**Reliable Energy, Inc.'s Comments on the IURC Director's Draft Report
on the 2021 Indiana Michigan Power Company's IRP**

June 8, 2023

Figure 1

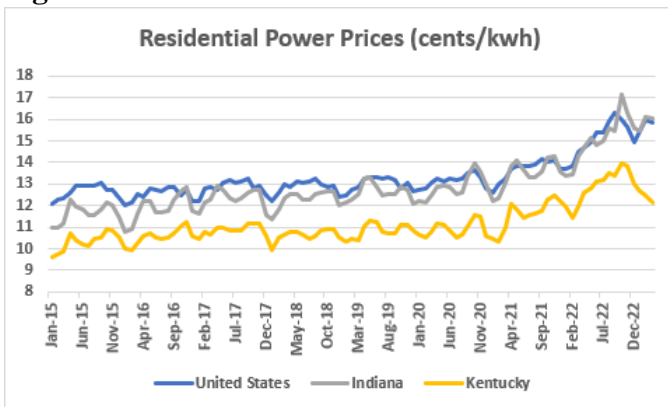
6. As Figure 1 demonstrates, residential rates in Indiana have increased at a faster rate than U.S. residential rates over the last seven years and now exceed national rates.⁵ In part, this is due to accelerated closure of coal plants with high cost replacements and continued charges to customers for stranded assets of the now closed plants. Given the consequence of high rates to the state economy, Reliable Energy encourages the Director and Commission to require that an IRP estimate the impact on residential rates associated with each resource strategy.

Figure 2.

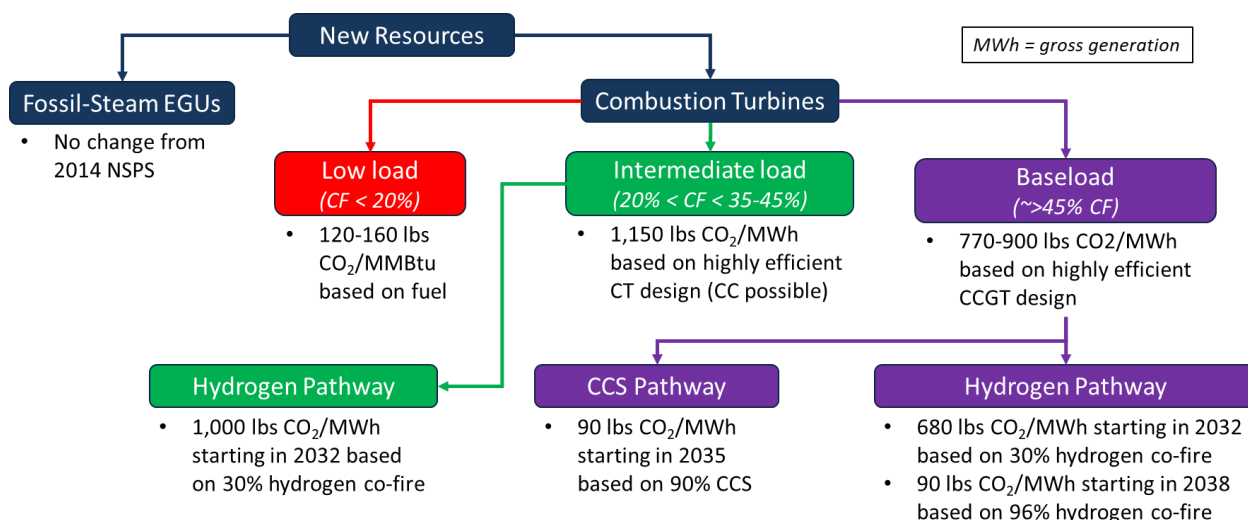
While Reliable Energy’s position was justified in its initial comments, it is even more compelling now. On May 23, 2023, EPA published proposed New Source Performance Standards (NSPS) for new natural gas combined-cycle combustion turbine plants (CCGT). Assuming this regulation is finalized as proposed, a new NGCC would either be required to start (about 30 percent) co-firing with low greenhouse gas (GHG) by 2032 increasing to about 96 percent co-firing by 2038 or installing carbon capture by 2035. This proposal is consistent with Reliable Energy’s prior recommendation that Indiana utilities should have either assumed a shorter life for new CCGT’s or included the cost of co-firing or carbon capture. A schematic of the proposed NSPS follows:

Notably, the EPA proposal also includes new standards for existing coal and natural gas baseload power plants. Existing CCGTs would be subject to similar rules as the new plants. Coal plants require co-firing with about 40 percent natural gas by 2030 if there is a commitment to close by 2040 or carbon capture if the plant is expected to operate past 2040. Despite regulatory uncertainty, the Commission would be ill-advised to approve non-compliant capital investments, particularly for new CCGTs which would be subject to the new NSPS as proposed. Utilities should accordingly be advised that any CPCN filings must reflect pathways and costs to achieve compliance with the proposed rules.
